SERVICE BULLETIN

NUMBER 165

SUBJECT: Aileron Hinge Reinforcing Bracket,
Part Number 10931-02

MODELS AFFECTED: J-3, PA-11, PA-15, PA-16, PA-17, L-18B
and L-4 Series

AILERON HINGE REINFORCEMENT BRACKET	
SERVICE BULLETIN	NUMBER 165
PIPER AIRCRAFT CORPORATION	
LOCK HAVEN, PENNSYLVANIA

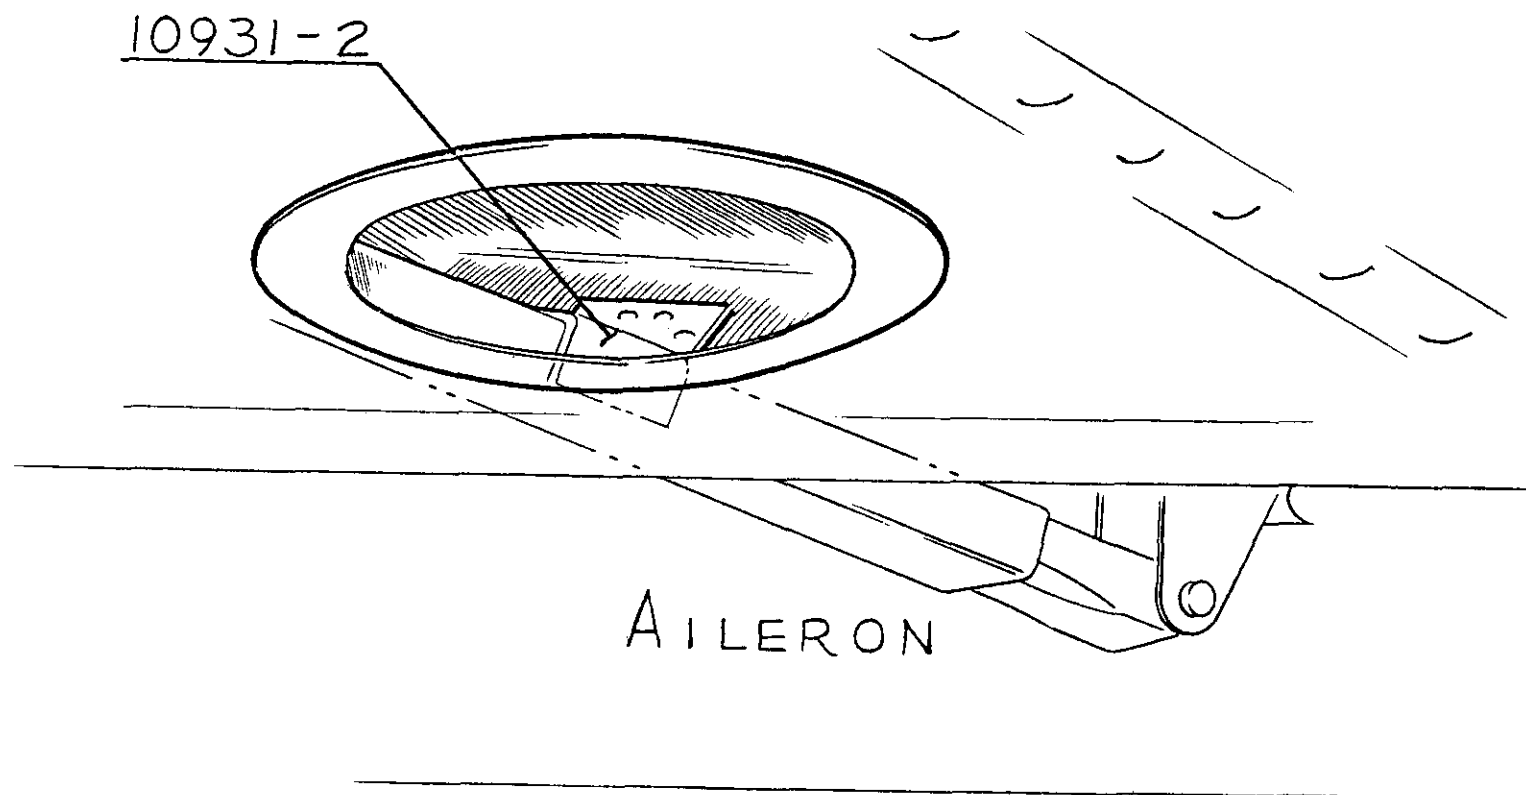
There is a possibility that a few of the subject parts have been supplied to the field during the past three years which were fabricated from aluminum instead of steel. It is requested that the subject brackets on the above mentioned airplanes, which have been replaced since June 1954, be checked to determine the type of material used to make this part. All brackets of aluminum construction must be removed and replaced with a steel bracket, part number 10931-02, which is available through your Piper distributor free of charge.

Please refer to the sketch on the reverse side of this bulletin for the location and identification of the subject bracket.
